PLANT NAME: Oconee 1-3

AMDT to OL/Change to Tech Specs: Consisting
of revisions with regard to miscellaneous
topics with the intent to update & improve
existing tech specs.....

Re: Oconee Nuclear Station
Docket Nos. 50-269, -270, -287

Pursuant to 10CFR50, §50.90, an amendment to the Oconee Nuclear Station Technical Specifications, Appendix A to Facility Operating Licenses DPR-38, -27, and -55 is requested. These proposed changes concern several miscellaneous topics and are intended to update and improve the Oconee Technical Specifications. Replacement pages for these proposed changes are attached.

OCONEE NUCLEAR STATION
STATION ORGANIZATION CHART
FIGURE 6.1-1

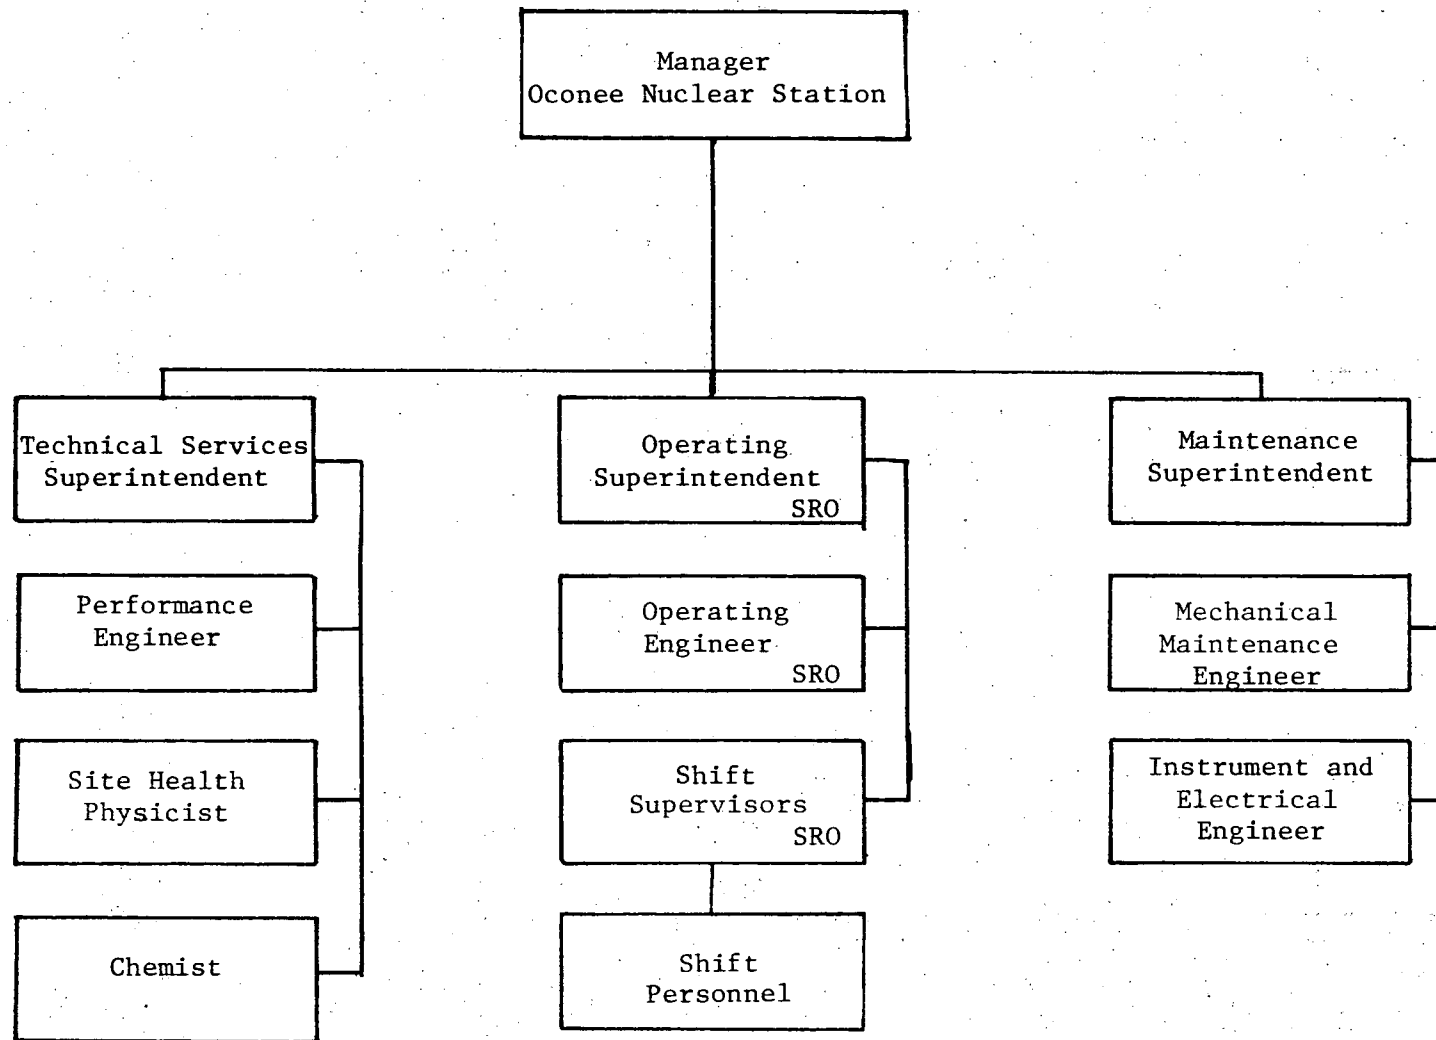
6. Technical Specifications 3.5.2.7, Table 4.11-1, 6.4.1, 6.5.2 and Figure 6.1-1 have been revised as indicated to reflect recent administrative changes and are self explanatory.
